PHASE 1 SCHEMATIC DESIGN

NSW DEPARTMENT OF
EDUCATION

NORTH SYDNEY PUBLIC
SCHOOL

SEC. 4.55 MODIFICATION ITEMS

SITE ENTRY

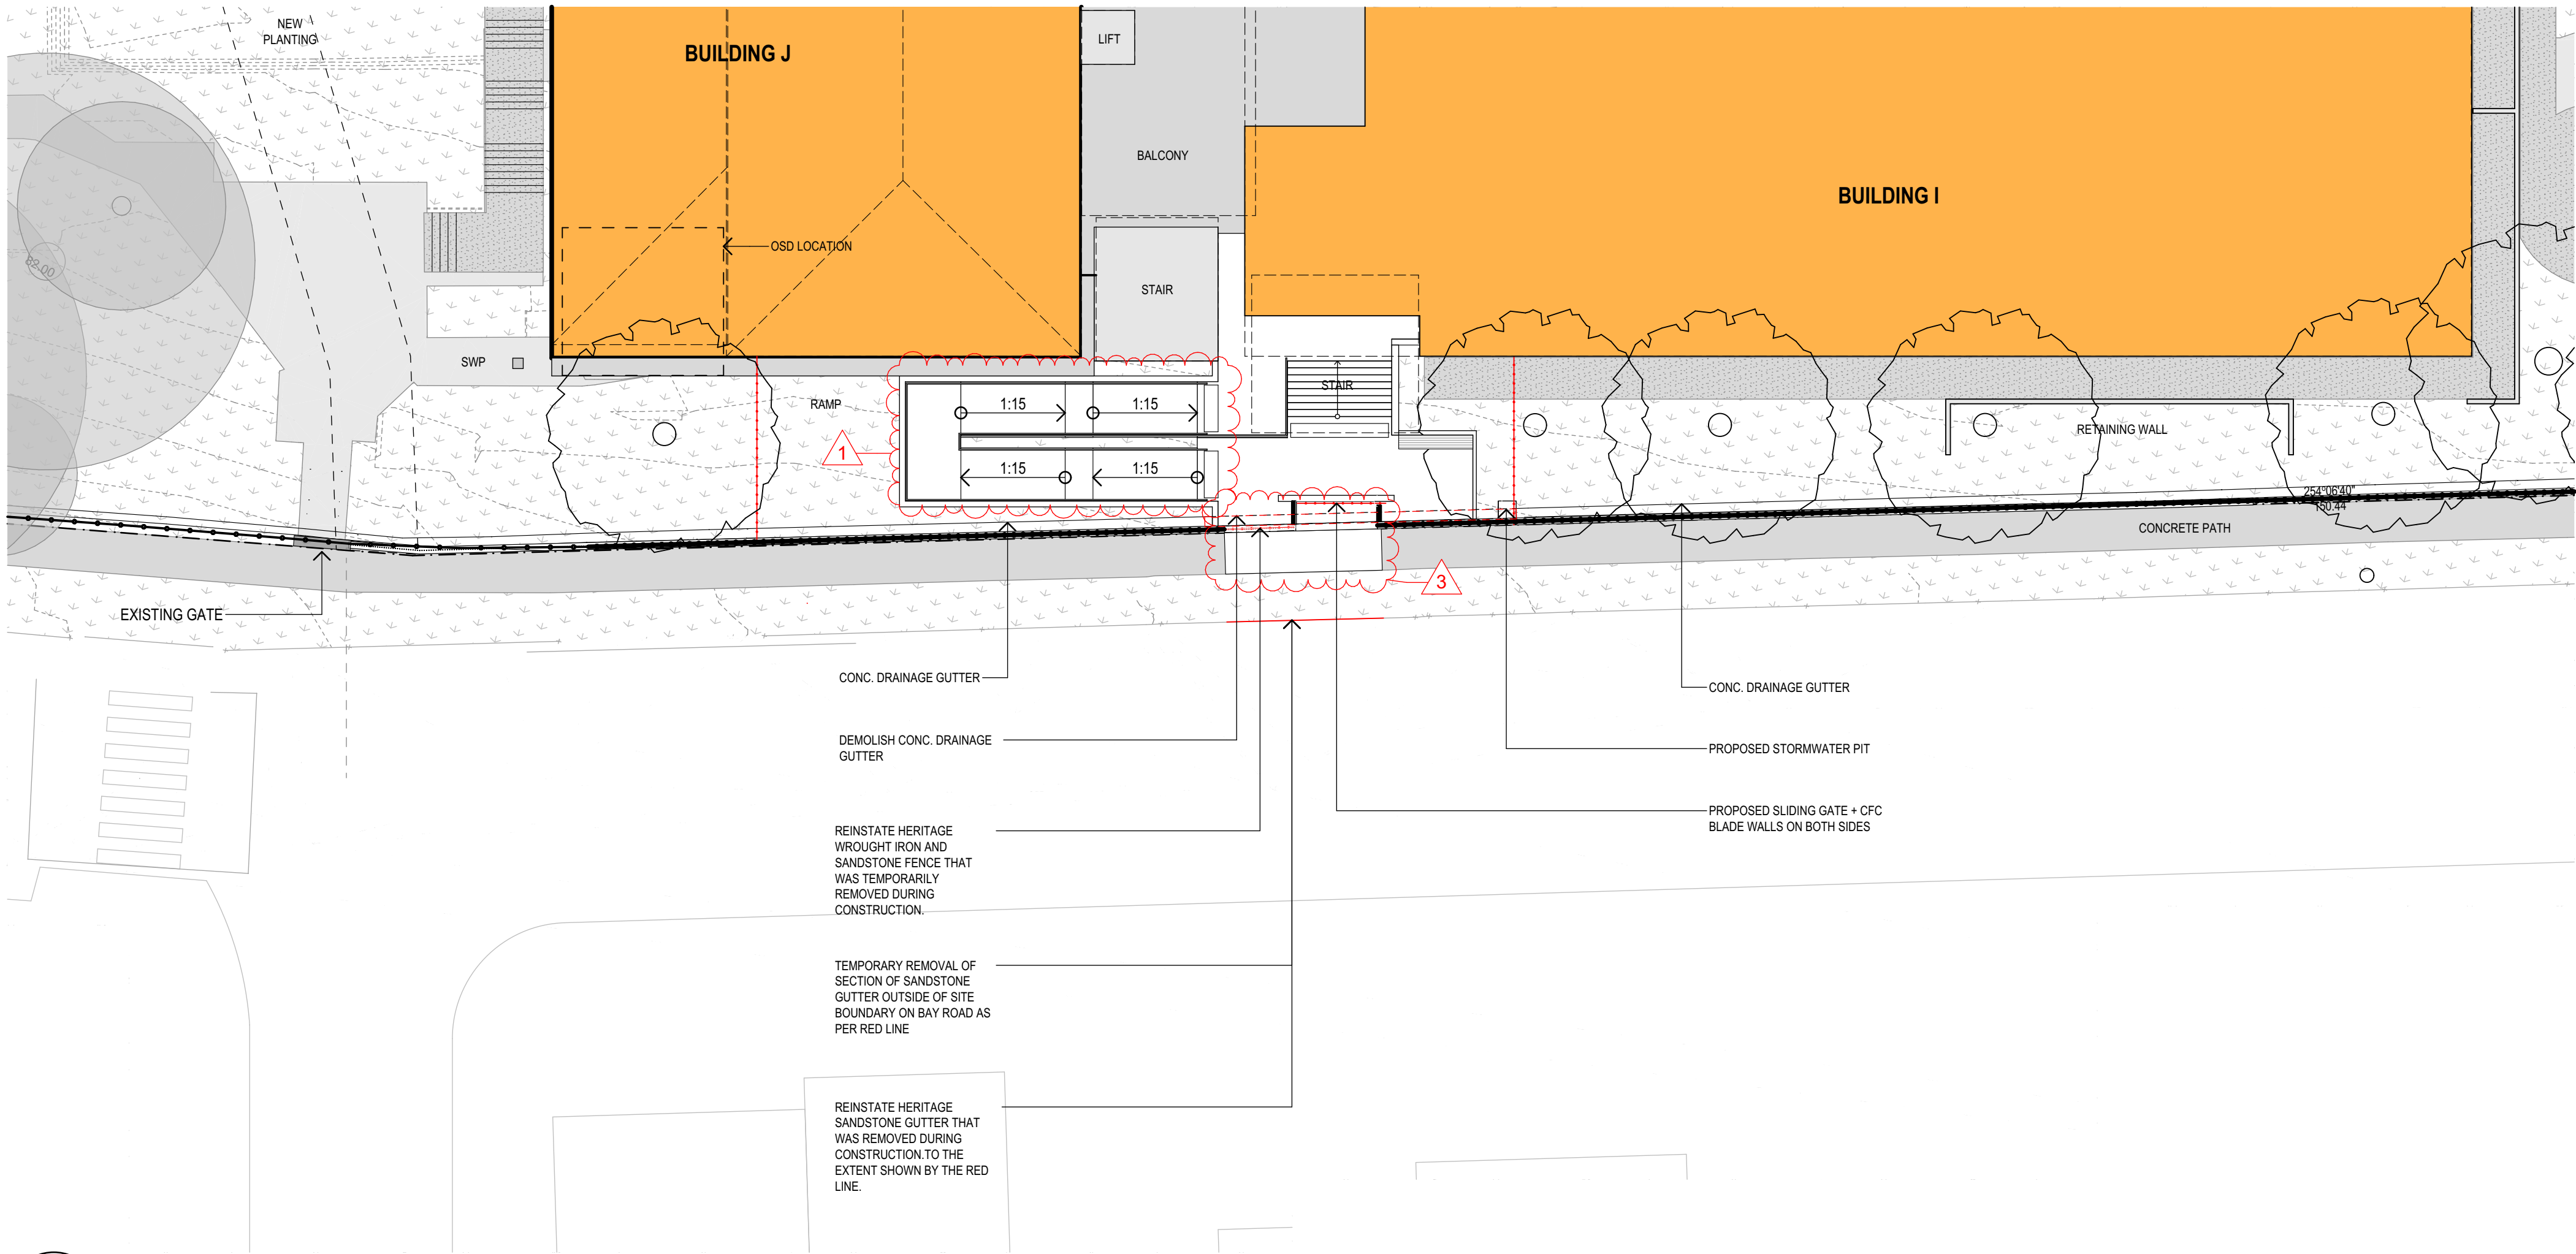
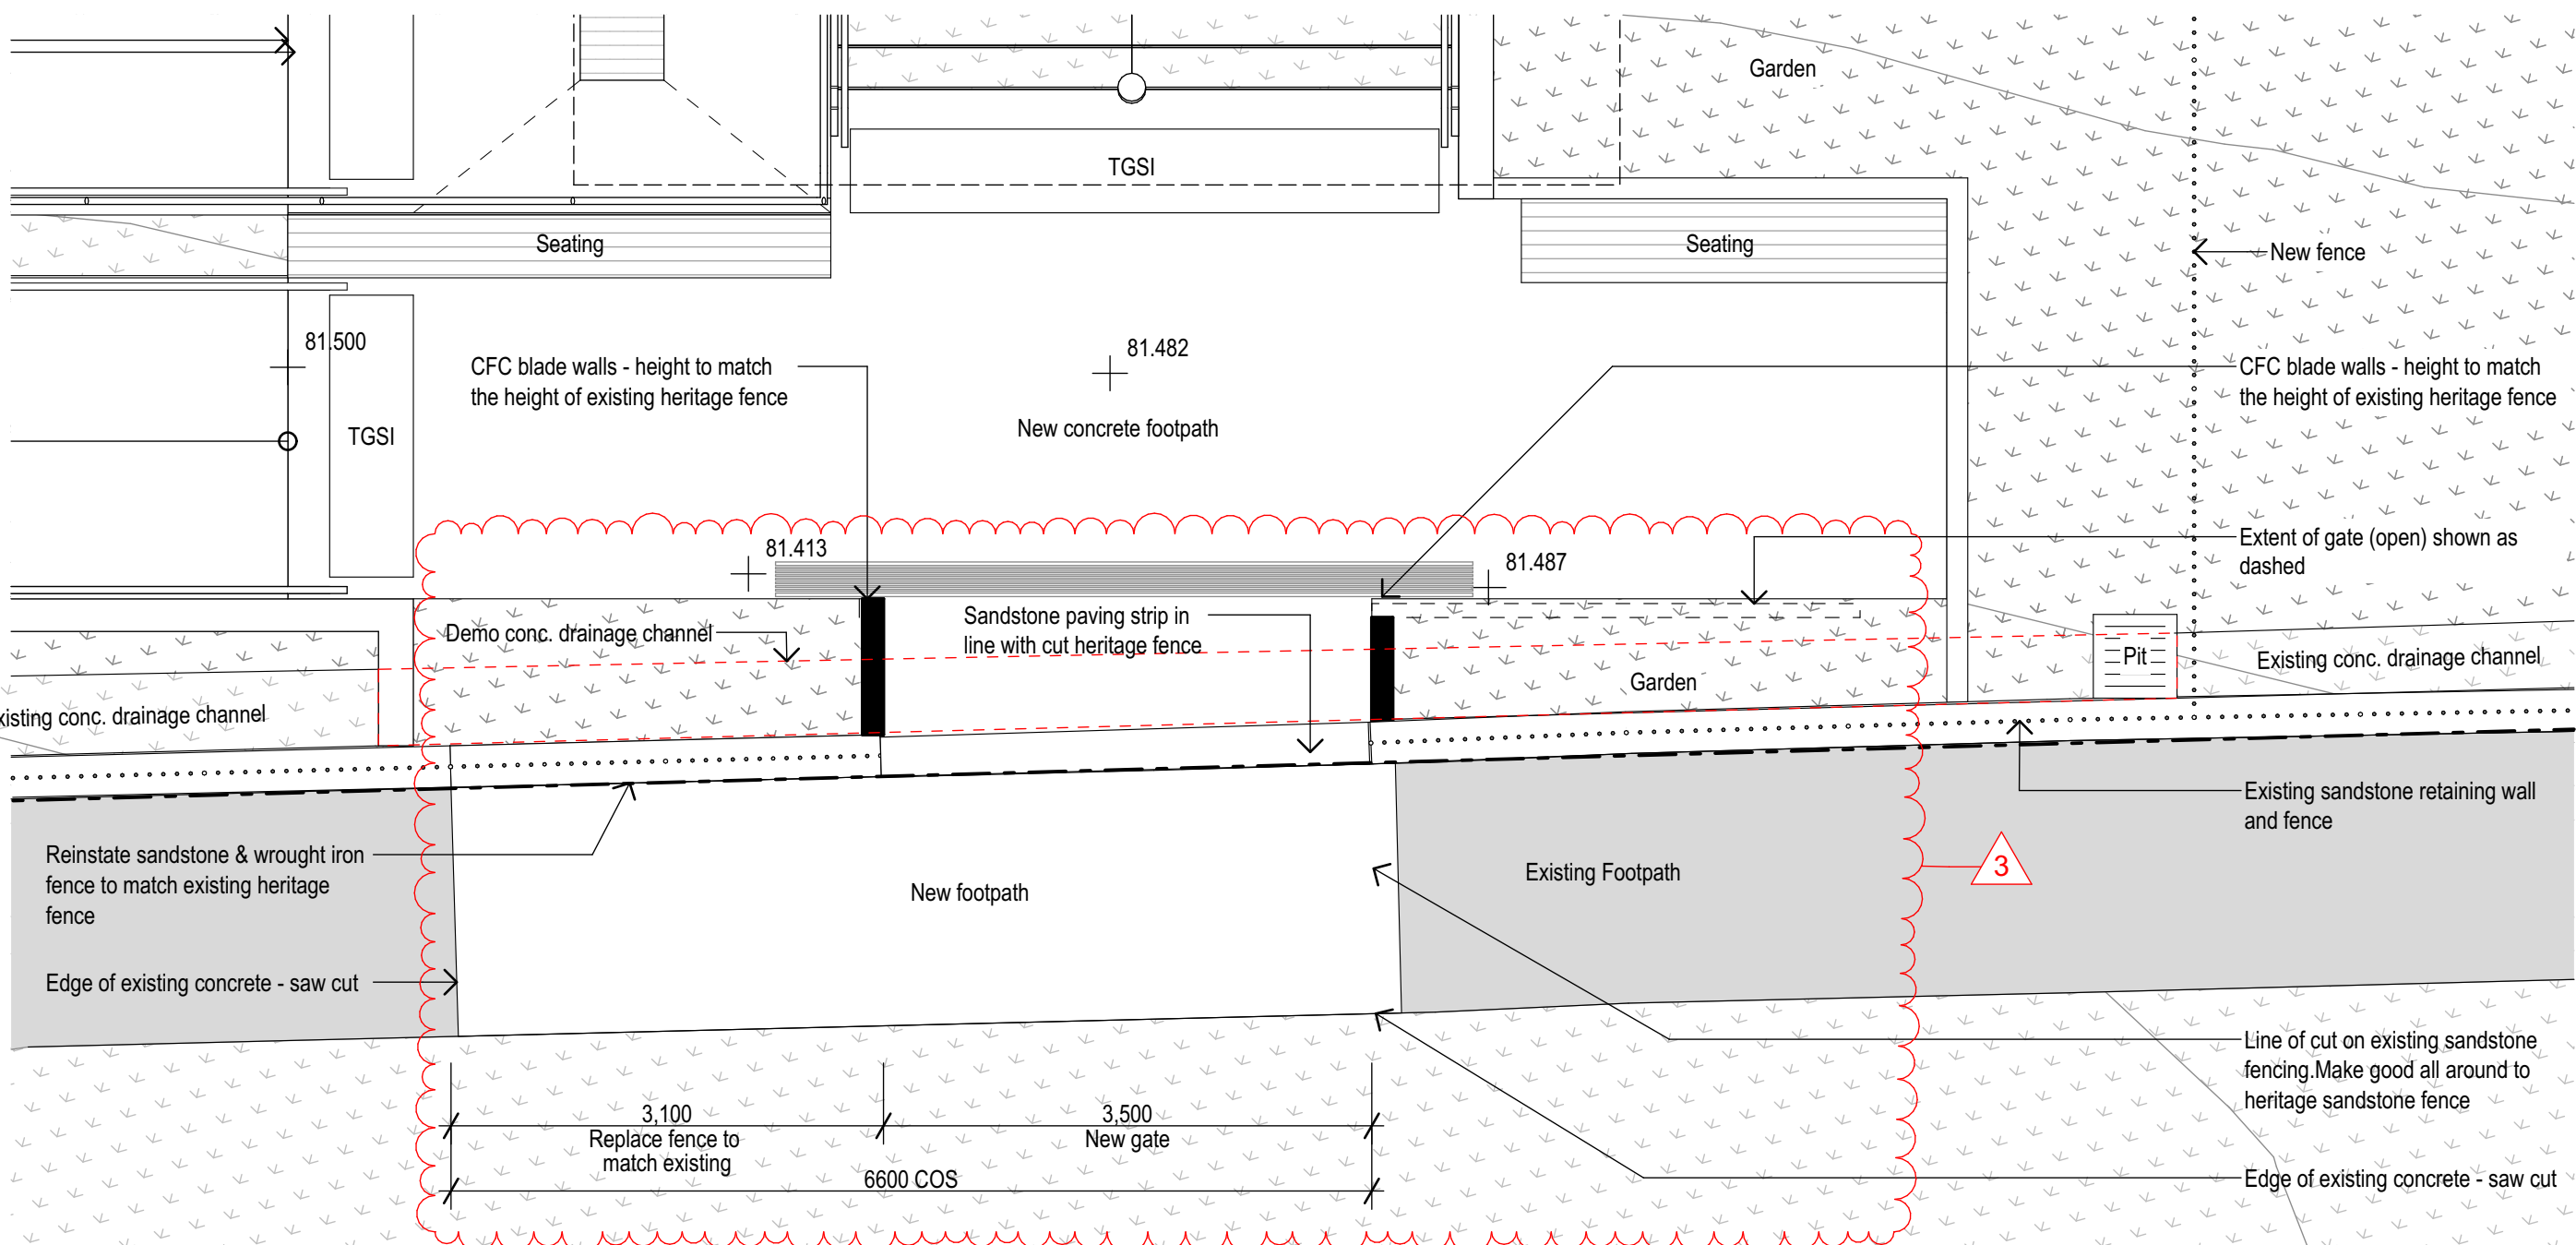
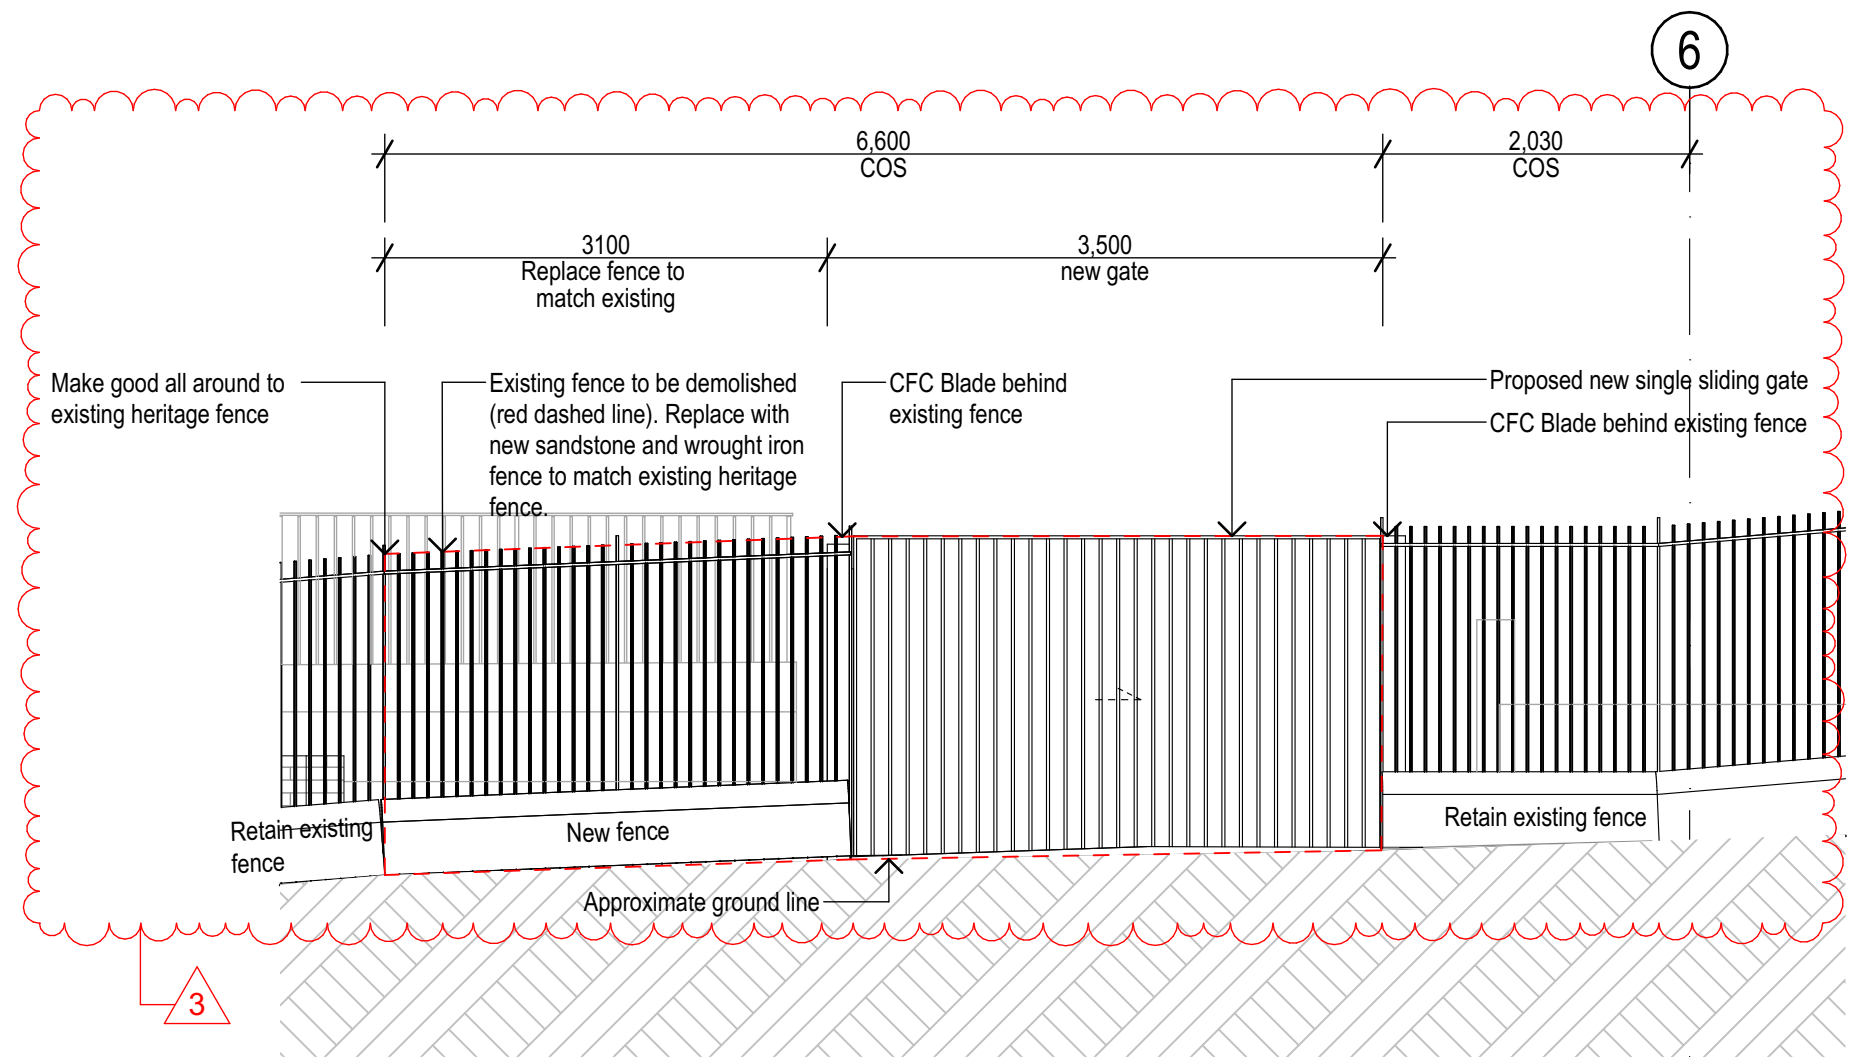
1 ENTRY RAMP RECONFIGURATION TO BE 1:15, ADDITIONAL SLAB TO ACCESS PLANT ROOM	7 WINDOW CHANGES TO BUILDING I SOUTH & EAST ELEVATIONS ON L1 / L2 / L3. WINDOWS INCREASED IN SIZE FOR COMPLIANCE WITH BCA PART F4 - LIGHT AND VENTILATION. FIXED GLAZED PANEL INTRODUCED TO LOWER SECTION OF L2 / L3 WINDOWS TO MEET MIN 1200MM SILL HEIGHT REQUIREMENT IN EFSG. LARGER OPENABLE AWNINGS INTRODUCED FOR NATURAL VENTILATION COMPLIANCE.
2 HYDRANT BOOSTER LOCATION	8 LOUVERED DOORS CHANGE FROM SINGLE TO DOUBLE DOOR TO SUIT PLANT ROOM REQUIREMENTS.
3 HERITAGE FENCE TEMPORARY REMOVAL	
4 ADDITIONAL CLEANER'S CUPBOARD	
5 LIBRARY ENTRY DOOR MOVED DUE TO CLEANER STORE BEING ADDED, NOW ALIGNS WITH LIFT	
6 WALL ALIGNMENT OF WC'S LEVEL 3
